SUBJECT: Letter of Clarification No. 3 for HVAC Installation at
Fire Station No. 20 for the General Services Departments

REFERENCE: Invitation to Bid No.: S50-C23357

**LETTER OF CLARIFICATION 3
HVAC INSTALLATION AT FIRE STATION NO. 20
SOLICITATION NO. S50-C23357**

CITY DWG. NO.:
M2.02

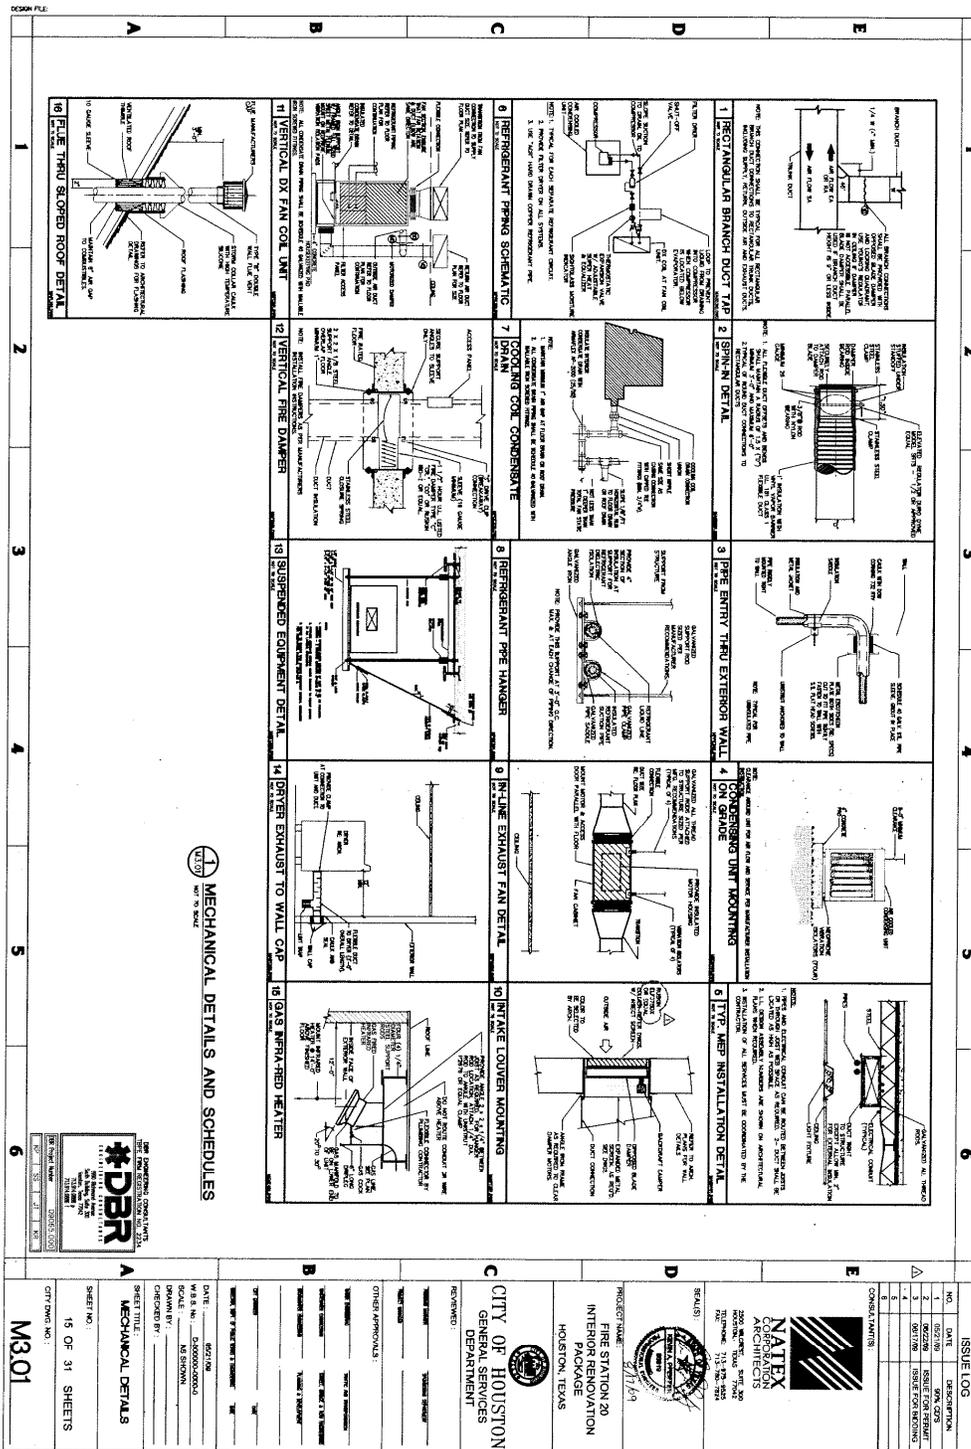
1. Drawing, M-2.01
 - Reference Letter of Clarification No. 2, paragraph 9, "Mechanical Keyed Note # 18, Make Up louvers is hereby deleted. However; BACK DRAFT DAMPERS (3) ARE PART OF THIS CONTRACT. See M-3.01 Detail # 10 and M-3.02 Fan Schedule. (See the attached Drawing, M-2.01)
 - EF-# 2, Mechanical Keyed Note # 13 is hereby deleted. Exterior wall louver by others for EF # 2 requires the third back draft damper listed on previous bullet. See M-3.01 Detail # 10 and M-3.02 Fan Schedule. (See the attached Drawing, M-3.01)
2. Drawing, M-2.02
 - Mechanical room fresh air louver only and EF-1 louver only with Mechanical Keyed Note # 9 are hereby deleted. (See the attached Drawing, M-2.02.)
3. Drawing, M-3.02
 - The attached DX SPLIT SYSTEM SCHEDULE replaces system schedule in the drawings, in its entirety. (See the attached Drawing, M-3.02 with Revised DX SPLIT SYSTEM SCHEDULE)
